PROJECT NUMBER: SP2022-048
PROJECT NAME: Site Plan for the Homestead Subdivision
SITE ADDRESS/LOCATIONS:

CASE CAPTION: Discuss and consider a request by Meredith Joyce of Michael Joyce Properties on behalf of Peter Shaddock, Jr. of SH Dev Klutts Rockwall, LLC for the approval of a Site Plan for the Homestead Subdivision being a 129.453-acre tract of land identified as Tract 6 of the J. A. Ramsey Survey, Abstract No. 186, City of Rockwall, Rockwall County, Texas, zoned Planned Development District 92 (PD-92), generally located at the northeast corner of the intersection of FM-549 and FM-1139, and take any action necessary.

DEPARTMENT	REVIEWER	DATE OF REVIEW	STATUS OF PROJECT
PLANNING	Henry Lee	08/26/2022	Needs Review

TRAIL HEAD REST STATION
PLAN

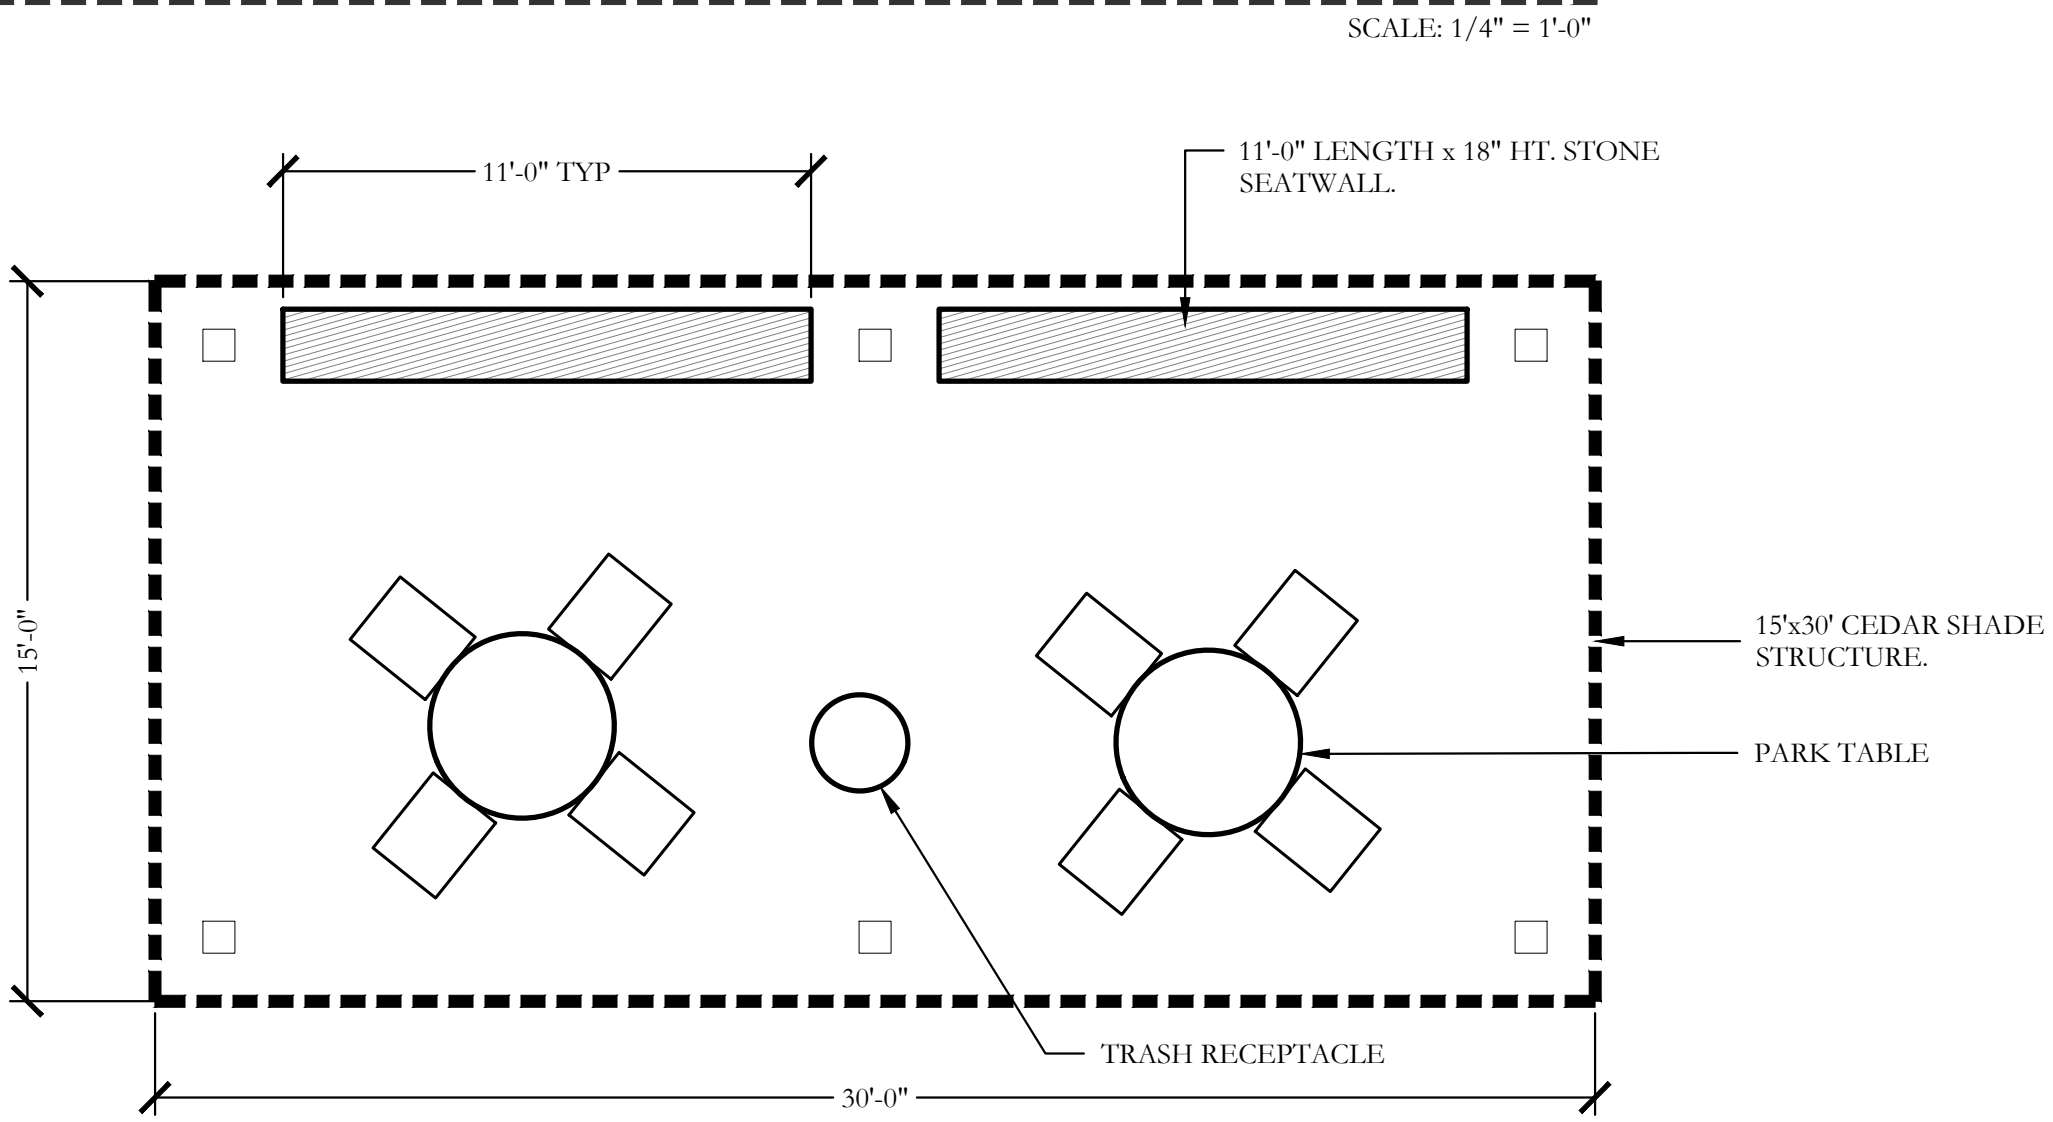
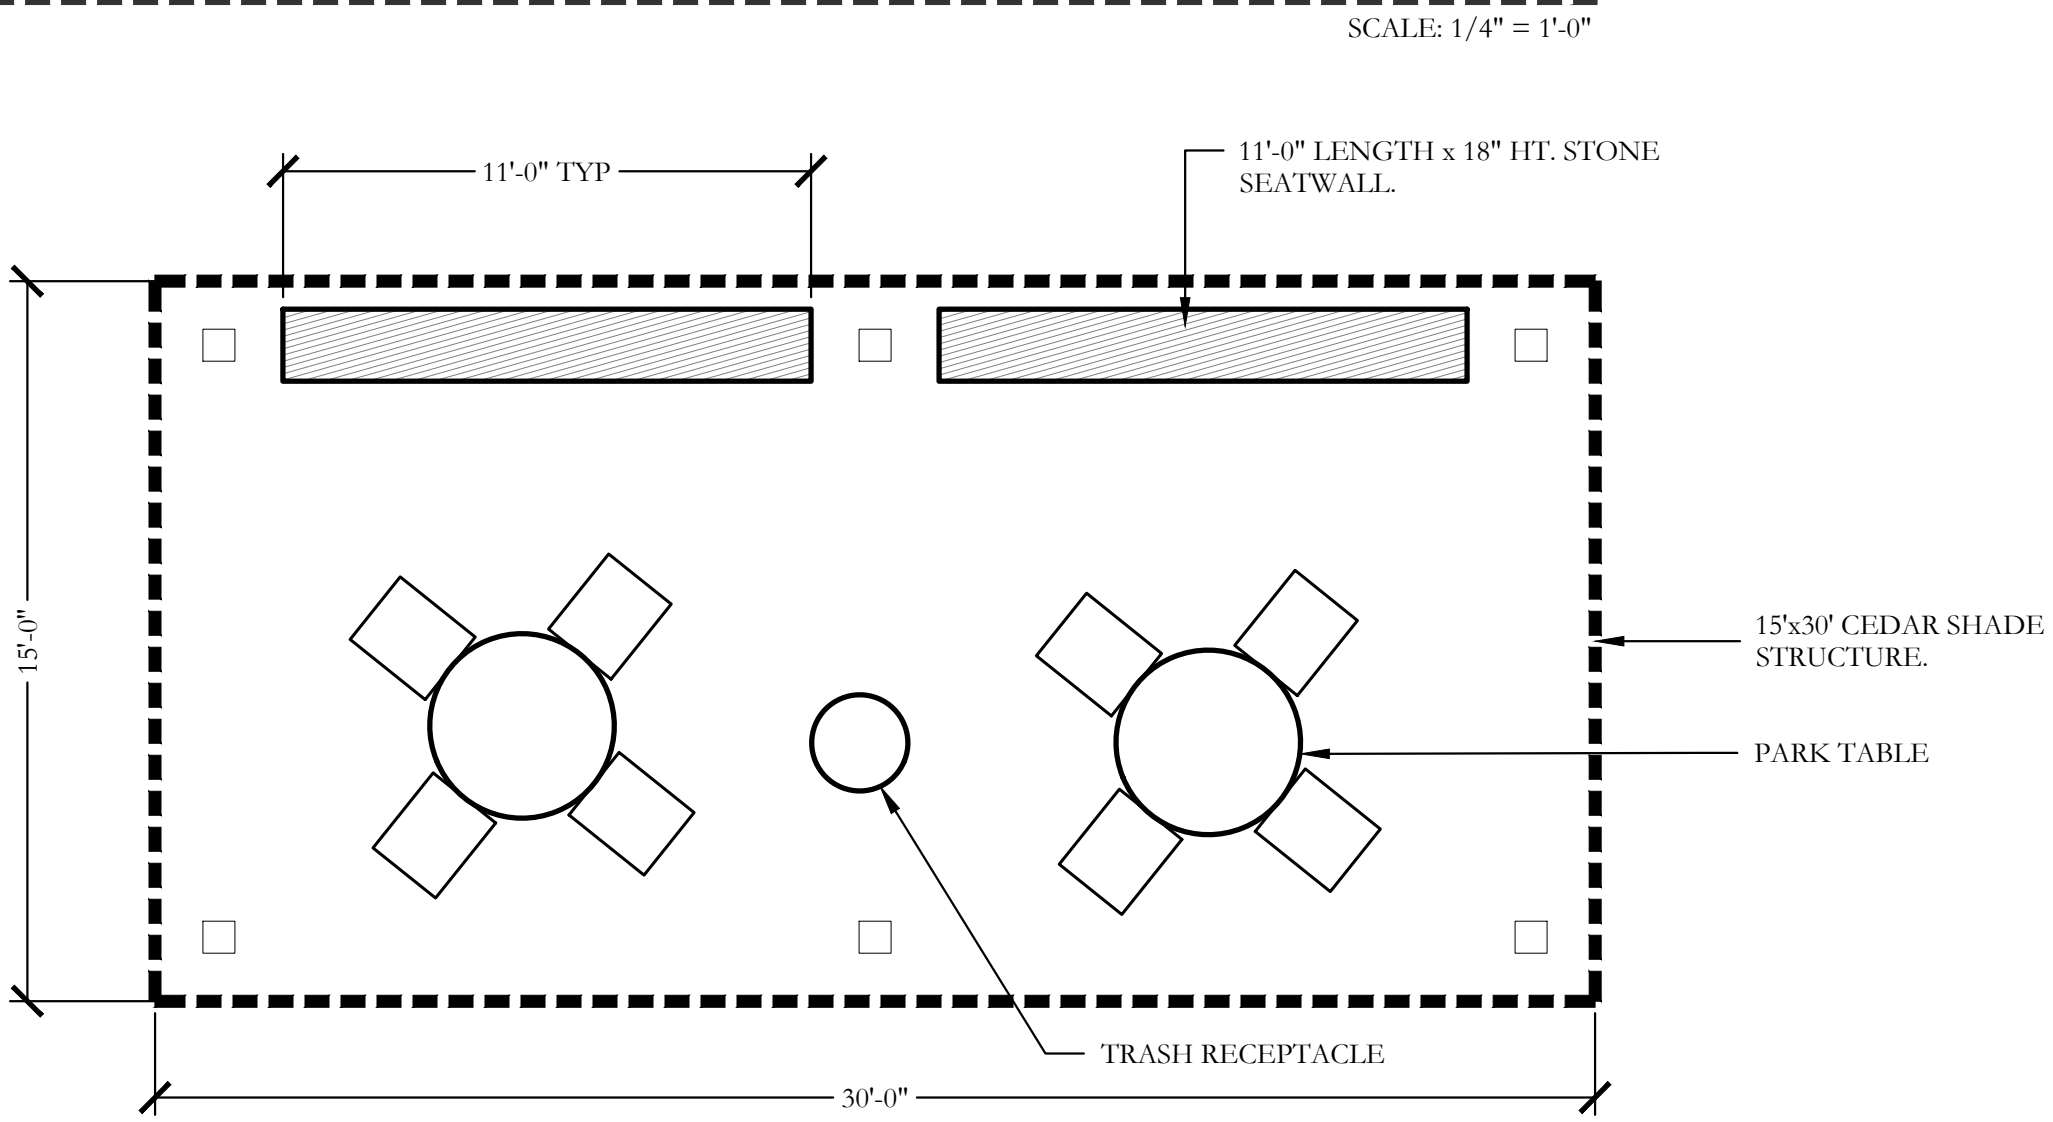
- (1) Provide a detail of the trail head rest station.
- (2) Provide a detail of the secondary entry monumentation.

PD SITE PLAN OF

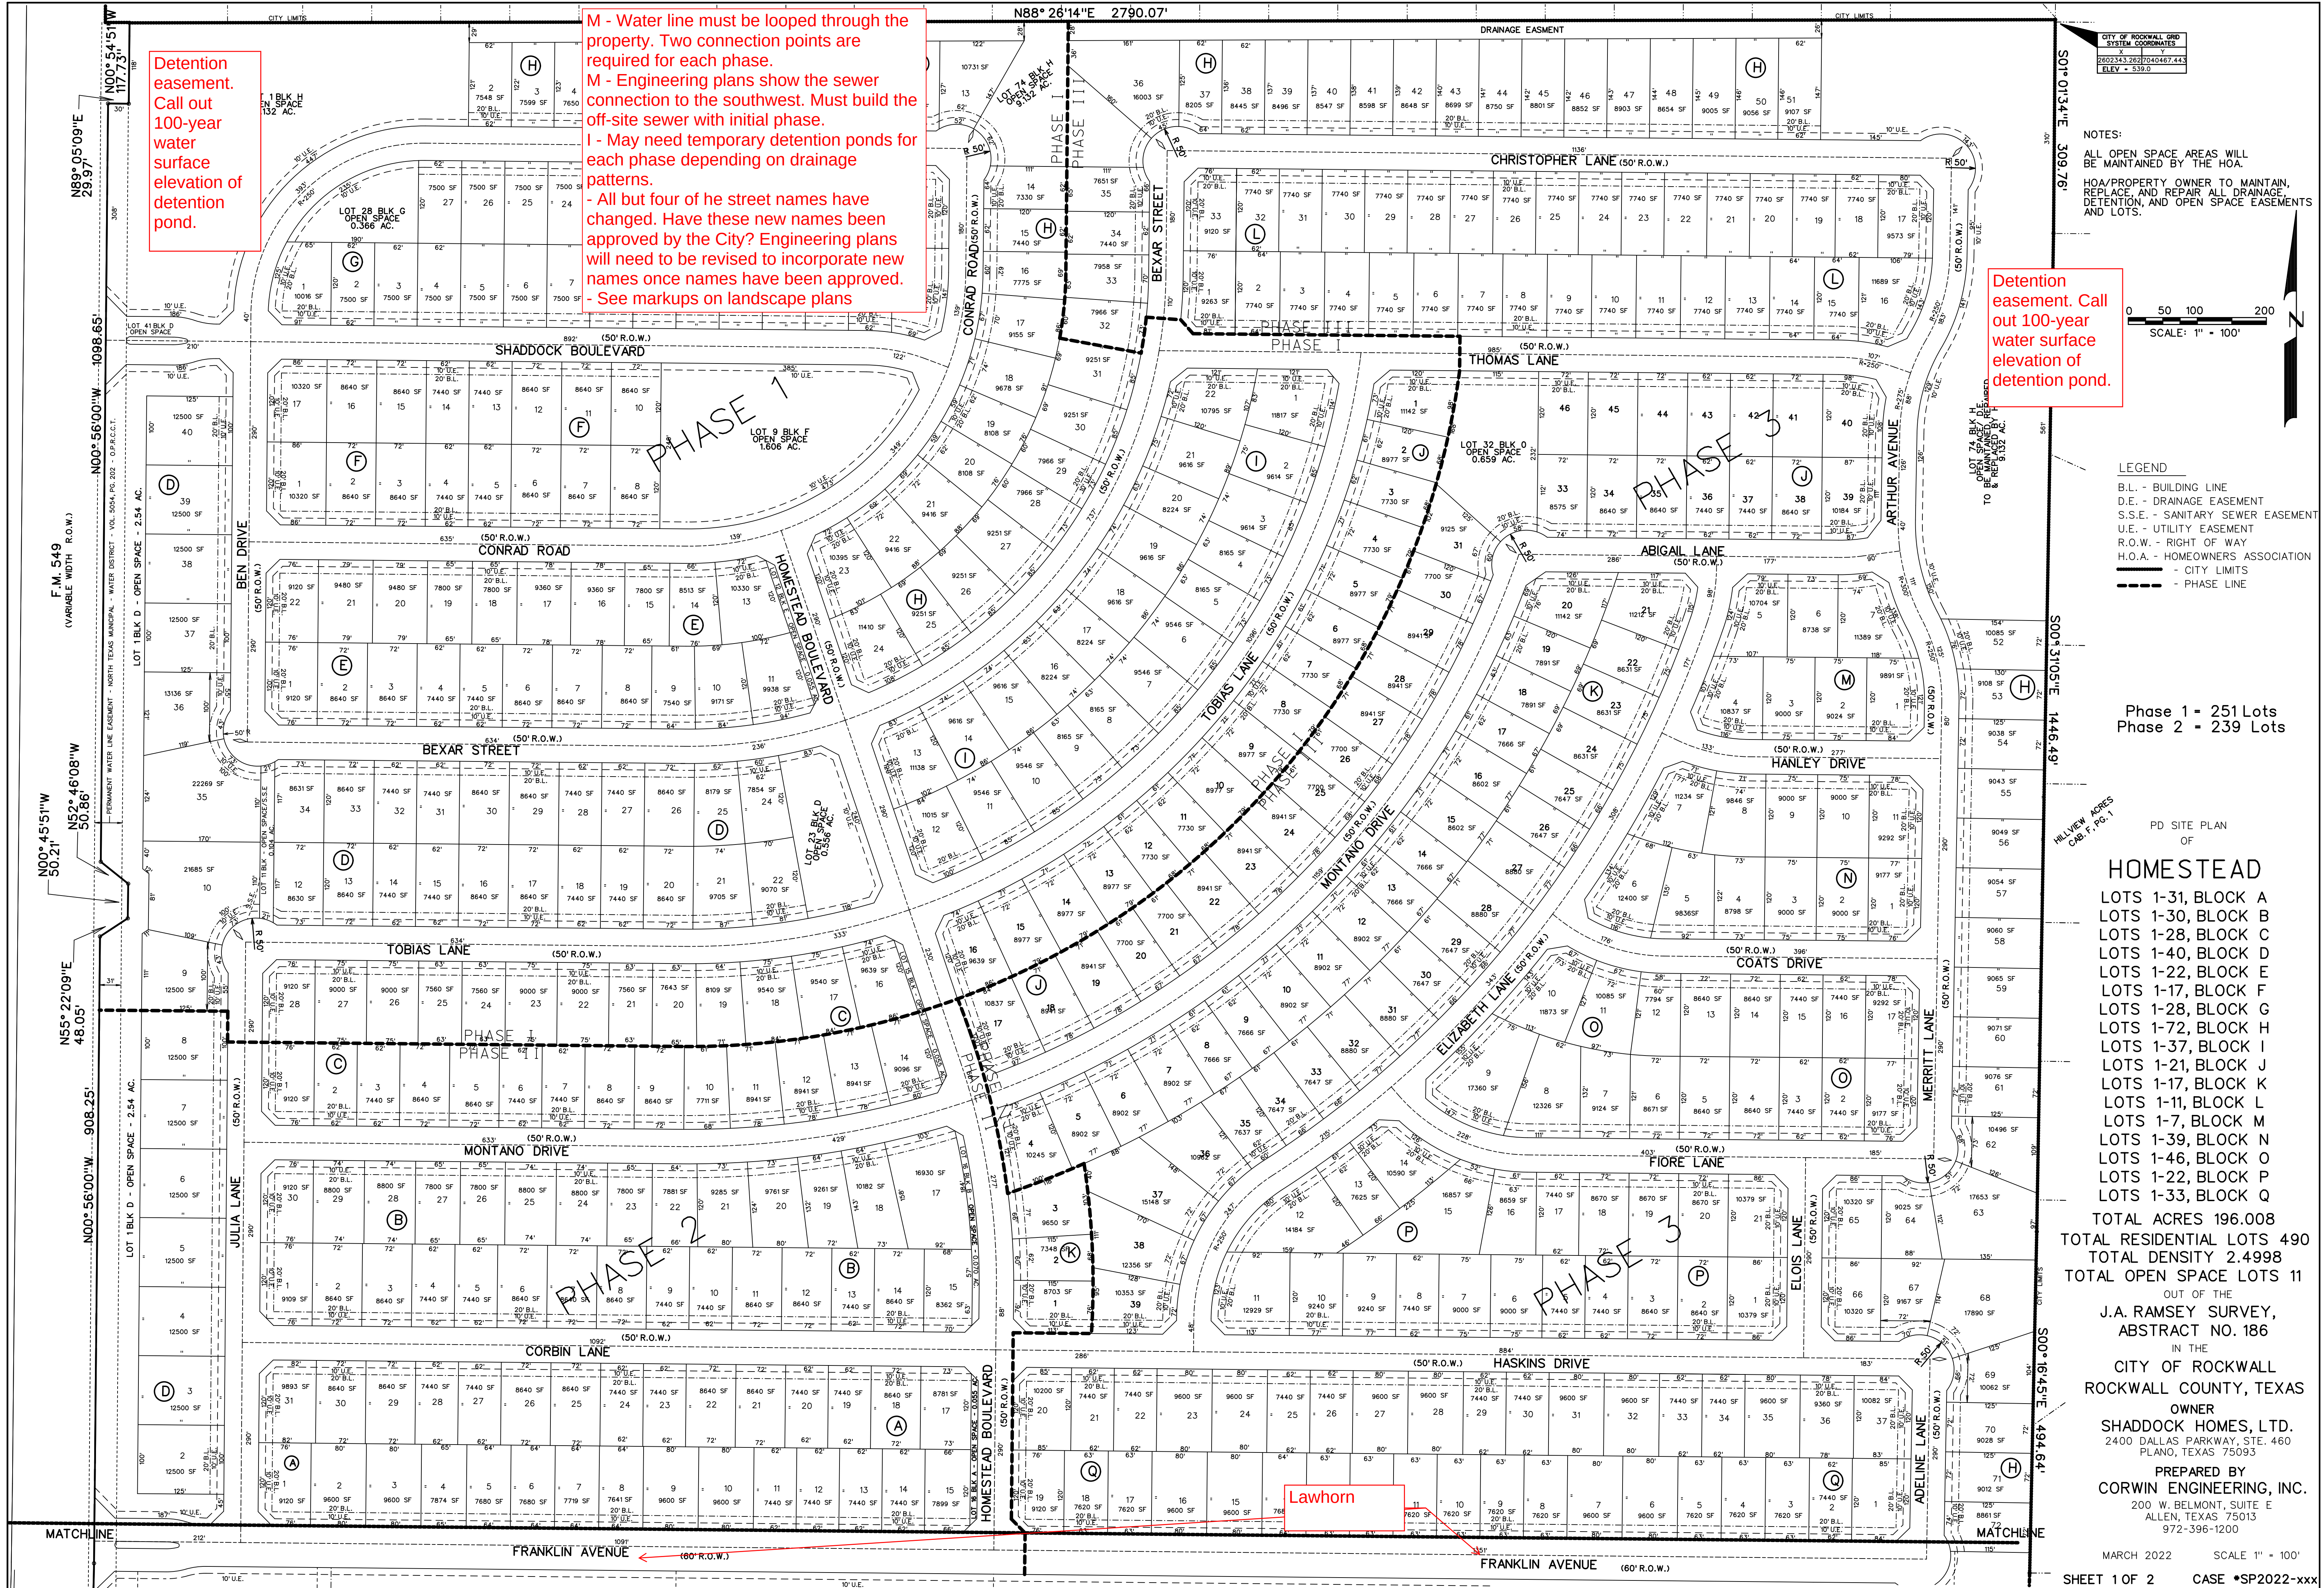
Please submit tree mitigation plan

Detention easement. Call out 100-year water surface elevation of detention pond.
